State of Idaho
Department of Environmental Quality
Technical Guidance Committee

Technical Guidance Committee Meeting

Draft Minutes

Thursday, August 18, 2016

Figure 4-9. Cross-sectional view of typical filter, valve, and meter assembly for a noncontinuous flush system.

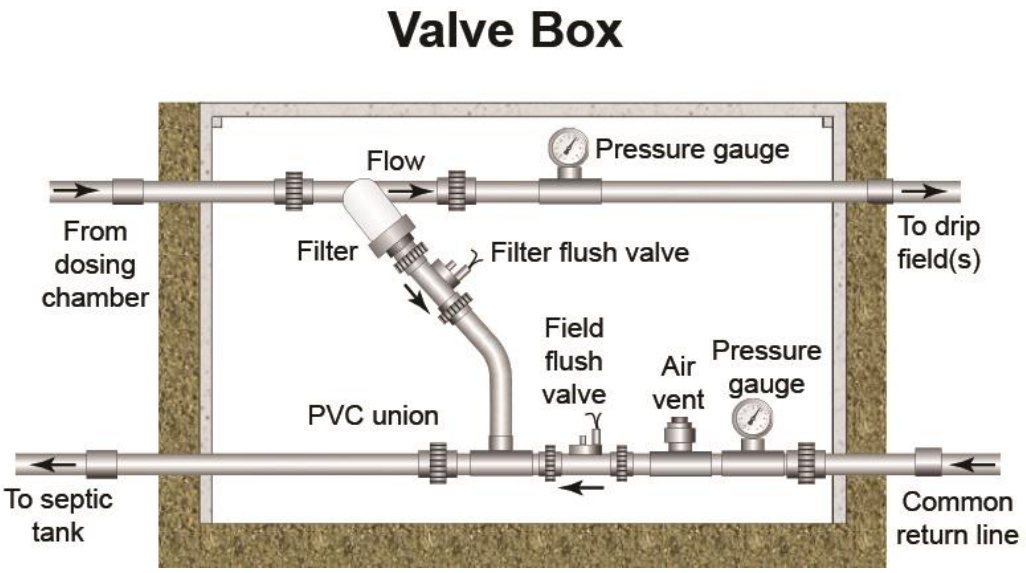
The committee requested the Tyler Fortunati have a pressure gauge added to the portion of Figure 4-9 labeled "to drip field".
